Project Title:
Residential Development, Nulgrove Avenue, Rintarham, DUBLIN 14

Response to Request for Further Information

Planning Application No: SD21A/0101

**For
Proposed 28 Unit Residential Development
At
Nutgrove Avenue, Rathfarnham, Dublin 14.**

Above: Extracts from Landscape Plan (362-DD-01) showing adjusted paths widths and planting bed widths.

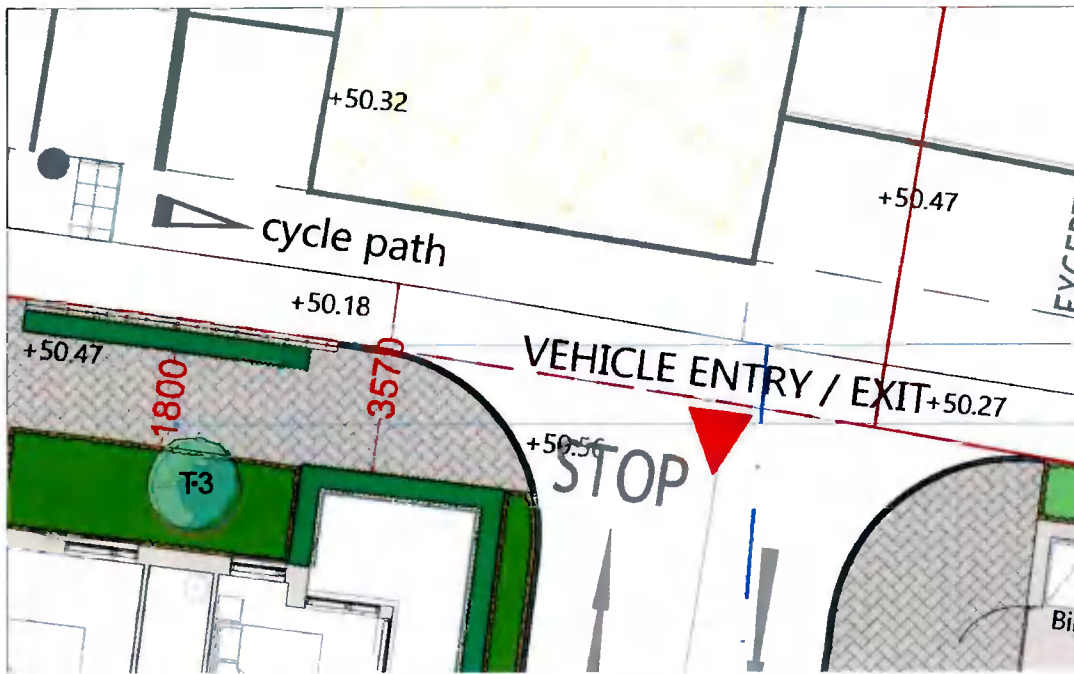
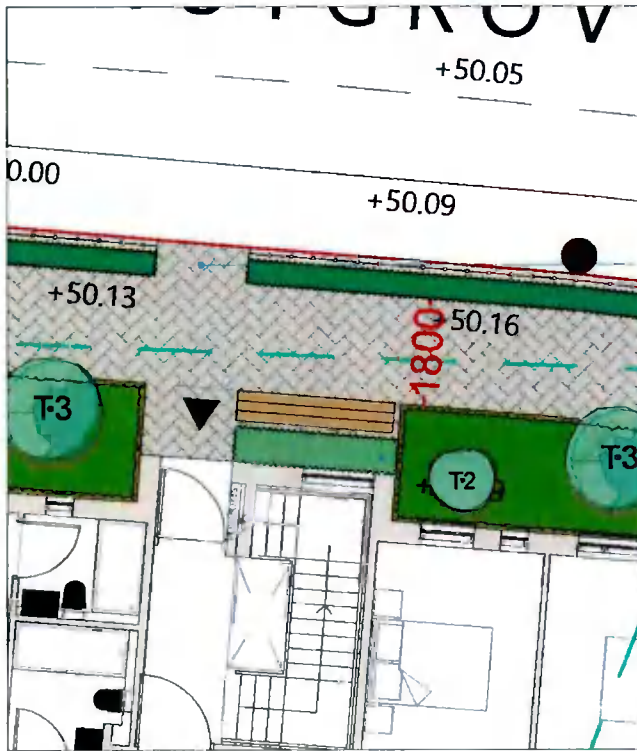
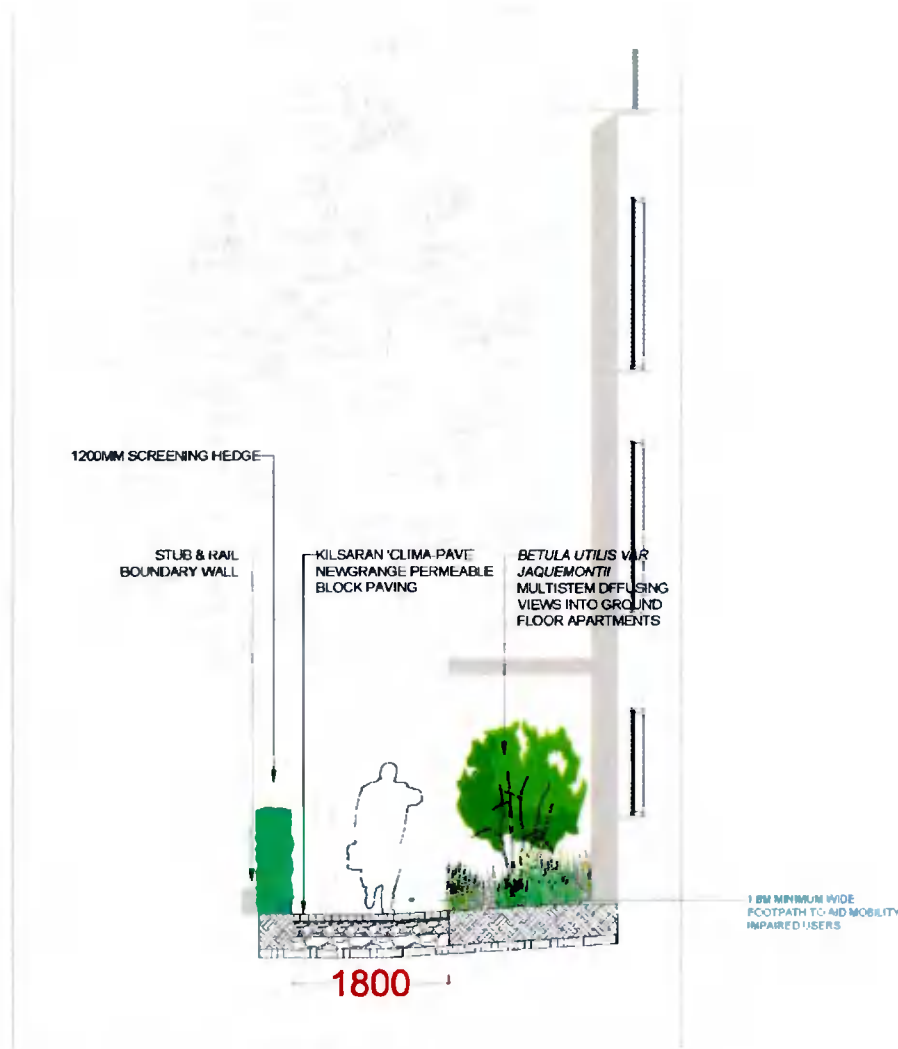
The footpath to the front of the development is split between a proposed walkway and the existing public footpath. This may lead to pedestrian confusion and lead to traffic hazard, particularly at the proposed vehicle access. Where the proposed footpath enters the carriageway before the stop line it should be possible to develop a combined pedestrian walkway across the front of the development to create greater than 1800mm wide footpath. A revised layout is requested showing pedestrian routes within and to the front of the development.

(a) The minimum width of footpaths should be 1.8m wide to aid mobility impaired users.

(b) The footpath layout should provide adequate connectivity around development and footpaths on the main road.

The footpath to the front of the development has been widened to 1800mm. As a consequence, we have made the necessary adjustments to the soft and hard landscaping treatments to accommodate these changes.

PROPOSED FOOTPATH MERGES WITH EXISTING PUBLIC FOOTPATH FOR A COMBINED PEDESTRIAN WALKWAY

1.8M MINIMUM WIDE PATH TO AID MOBILITY IMPAIRED USERS

CONNECTION BETWEEN PROPOSED FOOTPATH ON NEW DEVELOPMENT AND FOOTPATH ON THE MAIN ROAD

500MM BUXUS HEDGING BEHIND PUBLIC BENCHES

Above: Extracts from Landscape Plan (362-DD-01) showing changes in balconies and soft landscaping.

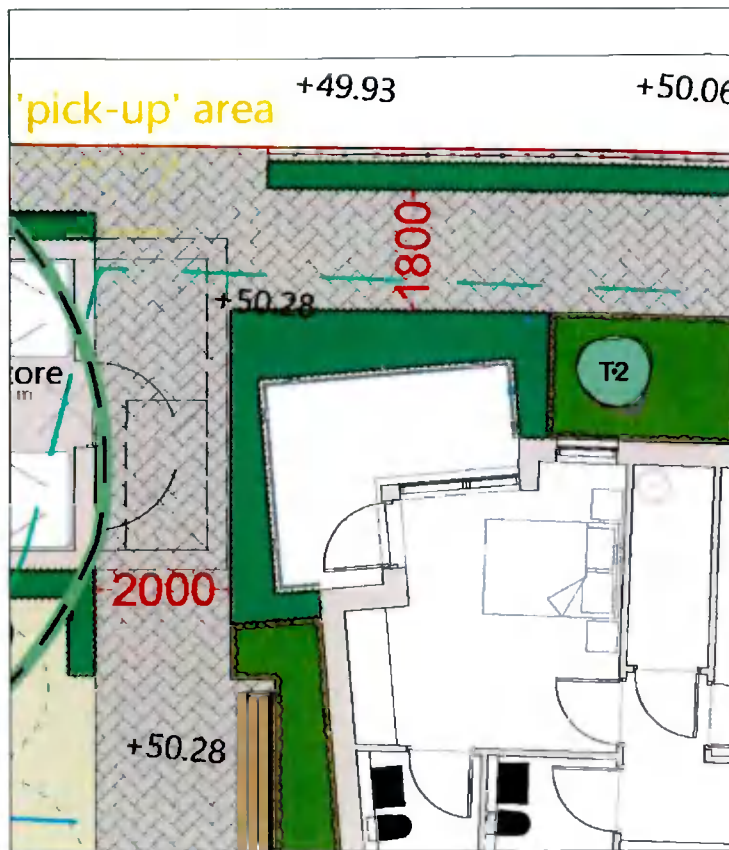
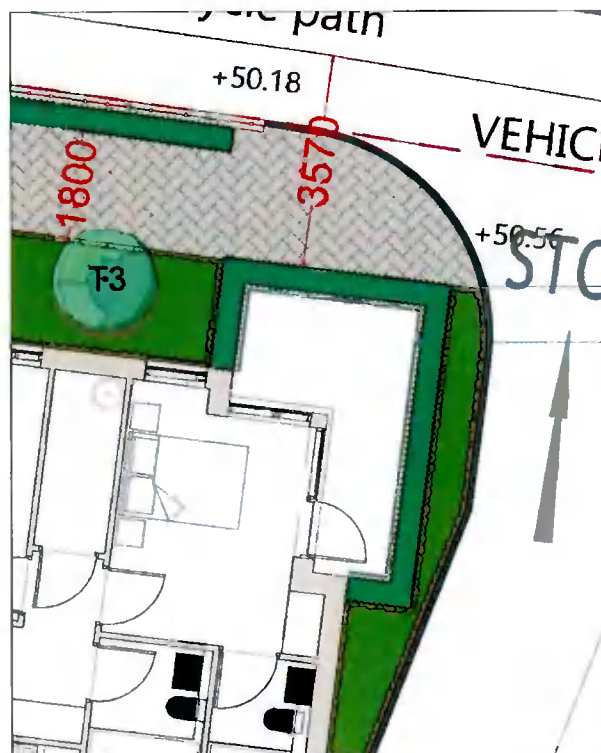
(2) Sections 3.37 of the Apartment Guidelines (2020) states that a minimum depth of 1.5m is required for balconies. The wrap-around balconies in the current form do not meet the 1.5m depth. The applicant is requested to provide revised plans demonstrating that each balcony meets this requirement.

Horan Rainsford Architects have provided a revised layout to address the above concerns. The revised layout includes increasing the depth of the balconies. Murphy+Sheanon have updated the Landscape plan to reflect these changes and have adapted the planting around the balconies, increasing the privacy screening measures.

1.2M PORTUGUESE LAUREL HEDGING SCREENING WIDTH OF HEDGE EXTENDED
INTERNAL WIDTH OF TERRACE/BALCONY INCREASED TO 1500MM

1.2M PORTUGUESE LAUREL HEDGING SCREENING
INTERNAL WIDTH OF TERRACE/BALCONY INCREASED TO 1800MM
ALONG THE NORTH, THIS AREA ACCOUNTS FOR THE 55Q M AREA GUIDANCE THE EXISTING WAYLEAVE PROHIBITS AN INCREASE OF TERRACE WIDTH TO THE EAST, HOWEVER THIS AREA FACILITATES TERRACE/BALCONY ACCESS AND PROVIDES ADDITIONAL AMENITY AND DUAL ASPECT TO THE APARTMENT

LEFT: Extracts from Landscape Plan (362-DD-01) showing changes to bin storage and proposed screening around bin storage.

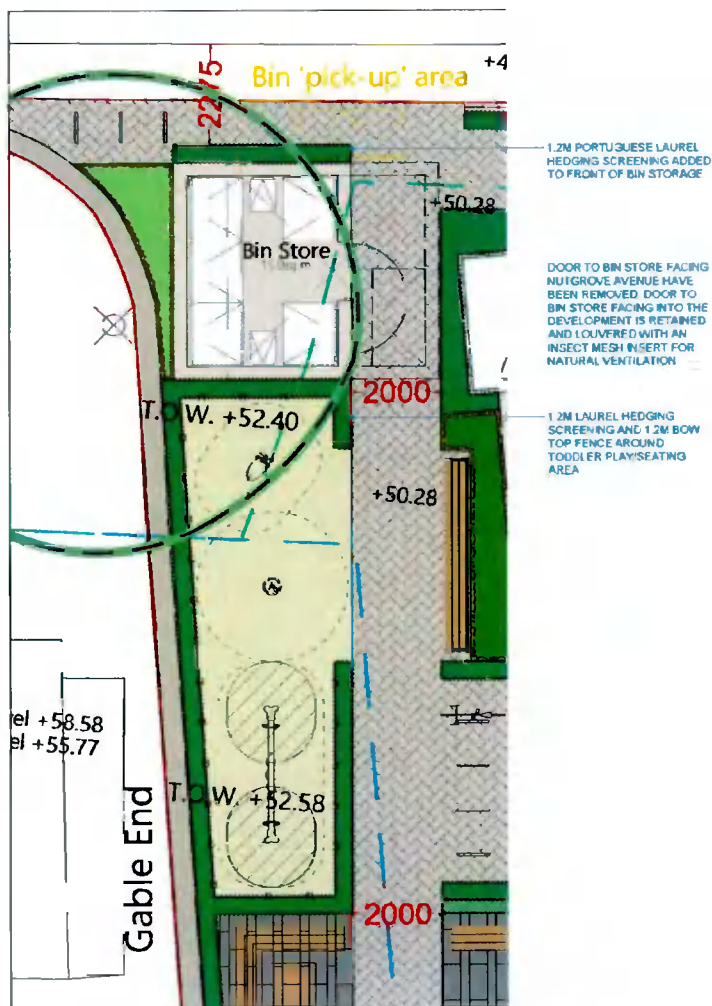
Given the proposed siting of the bin storage unit, in particular on the north-western side of the site in close proximity to an existing residential property and a proposed toddler play/seating area, that would be visible from the street, the applicant is requested to submit the following information:

- (1) A waste management plan and measures to prevent access from non-residents given the proximity of the storage units to the street.
- (2) Details of the capacity of the bin storage units to accommodate enough bins, including general waste, recycling, and organic waste, for the number of units proposed and to comply with waste management standards.
- (3) Details of the design of the storage units to include ventilation and measures to reduce odours.
- (4) Details of screening to reduce the visual impact.

Horan Rainsford Architects have provided a revised layout to address the above concerns. The revised layout includes moving the doors to the bin storage away from the front of the development to prevent non-residents from having easy access. In response to this, Murphy+Sheanon have updated the landscape plan to include an evergreen hedge to the north of the bin storage as a screening measure to reduce visual impact. This treatment has also been applied to the bin-store located to the north-east of the site.

Screening measures taken around the proposed toddler play/seating area include hedging and bow top fencing around the perimeter. Examples of this can be seen in the images below.
